SALEM GENERATING STATION
EVENT CLASSIFICATION GUIDE TECHNICAL BASIS
February 28, 2002

CHANGE PAGES FOR
REVISION #12

SALEM ECG TECHNICAL BASIS
TABLE OF CONTENTS/SIGNATURE PAGE

REVISION SUMMARY

SYSTEM ACTUATION FLOW CHART

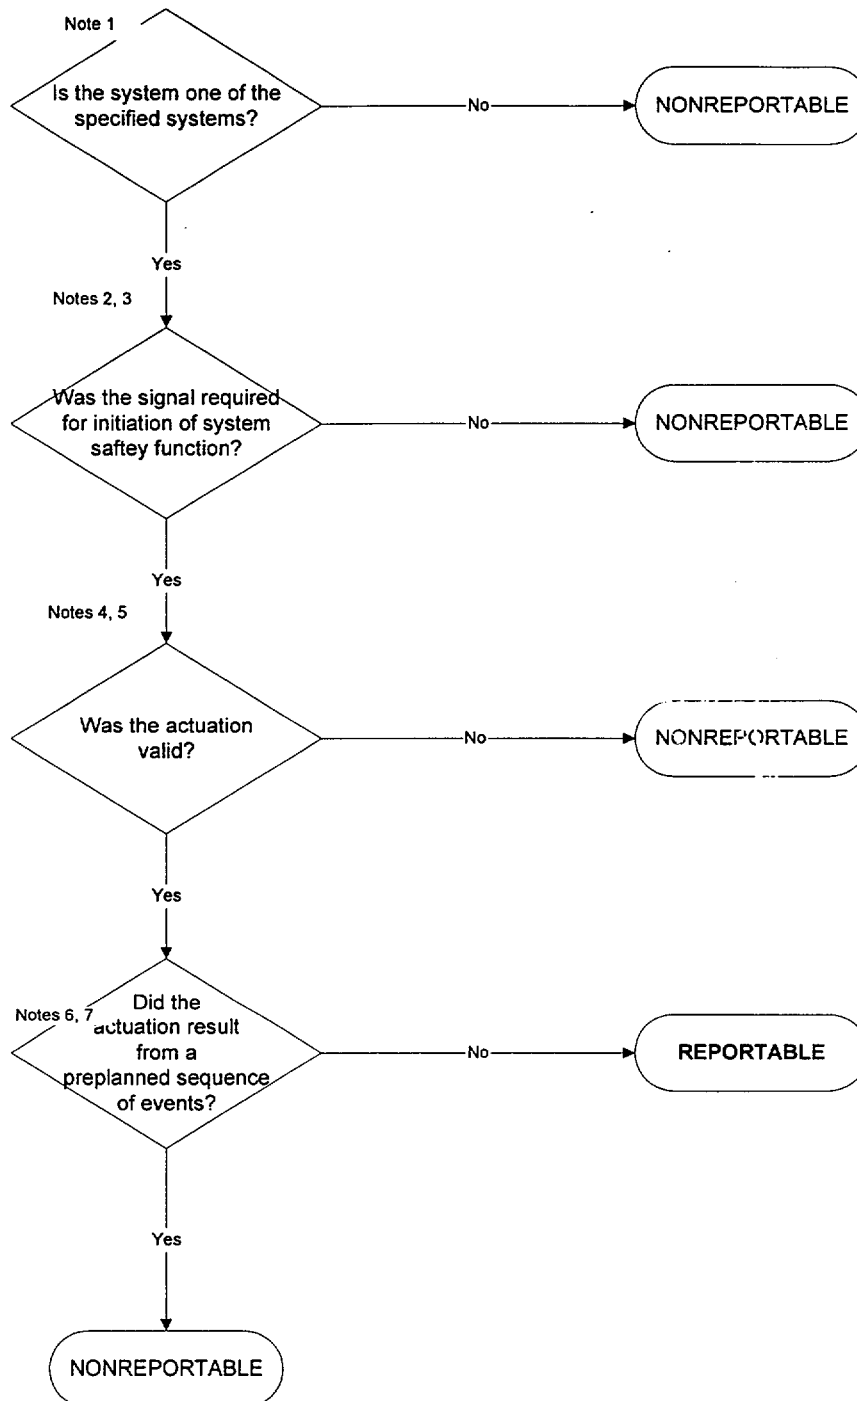
- 11.3.1 Technical Basis - added statement that manual actuations as directed by abnormal or emergency operating procedures are reportable.
- 11.3.3 Technical Basis - added RPS trip functions to list of reportable actuation signals and added statement that manual actuations as directed by abnormal or emergency operating procedures are reportable.
- RAL 11.6.1 and Technical Basis - revised after-the-fact reporting to conform to the guidance in the ECG Introduction
- RAL 11.7.1.b and Technical Basis - revised to state that loss of all met data for a single parameter (temperature, wind speed or direction) is reportable.

6. Manual system actuation to mitigate the consequences of an accident, assuring safe shutdown of plant is reportable. Manual actuation as directed by normal operating or test procedures is not reportable. Manual actuations as directed by abnormal or emergency operating procedures (i.e., not part of a preplanned test or operational evolution) are reportable.
